Office Action Summary

10/815,594

BETHGE ET AL.

DETAILED ACTION

Fig. 1a

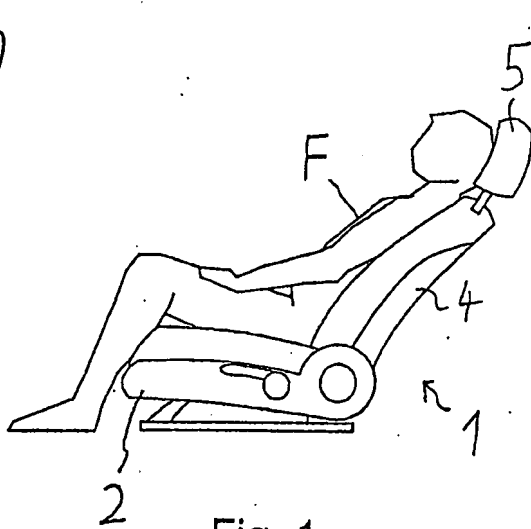
Generally it is not clear how Figures 3a-3d and 4a-4d relate to Figures 1a-b (i.e., are these different embodiments? If not, how does, say, the invention change from

Figure 3a to Figure 3b without reconstructing the invention in midtravel?). Similarly, it is not clear how Figure 3a relates to Figure 3c, 3d, etc.

Fig. 3

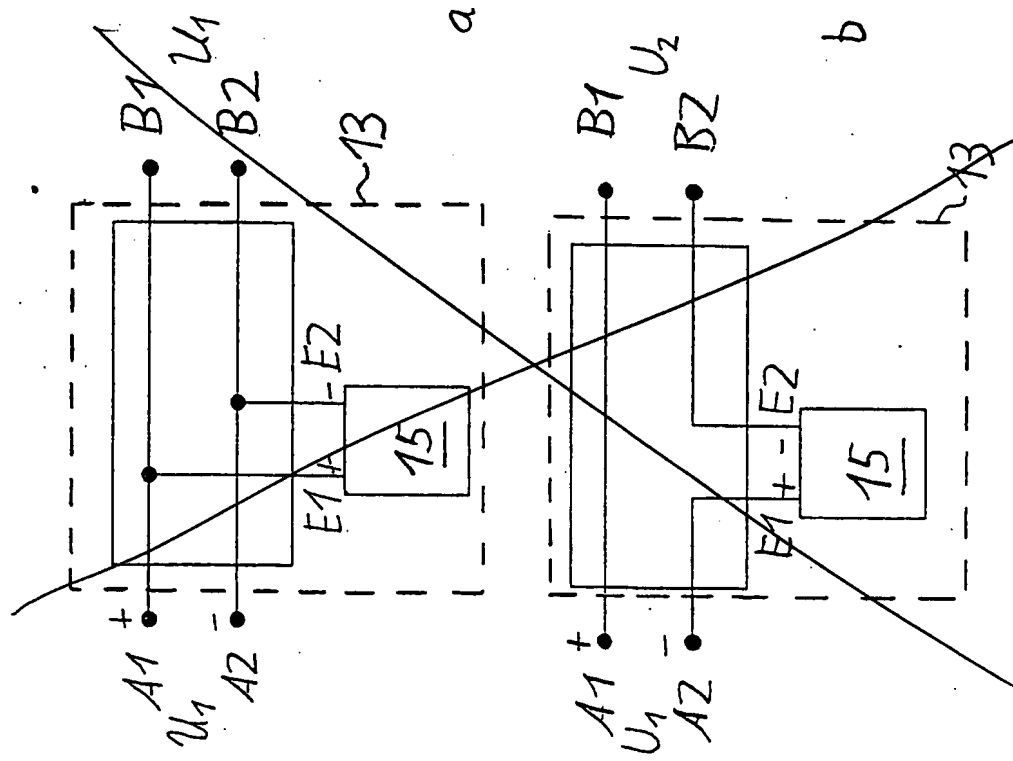
1. The drawings were received on 8/27/07. These drawings are approved.
2. Also, applicant indicated on page 9 of the 8/27/07 response that the second Figure 3 is deleted, but no indication of this was made in the drawing corrections. Hence, the examiner is enclosing an approved photocopy of the canceled Figure 3.
3. The drawings are objected to under 37 CFR 1.83(a). The drawings must show every feature of the invention specified in the claims. Therefore, the sliding roof adjusting device and window lifting device (claim 7) must be shown or the feature(s) canceled from the claim(s). No new matter should be entered.
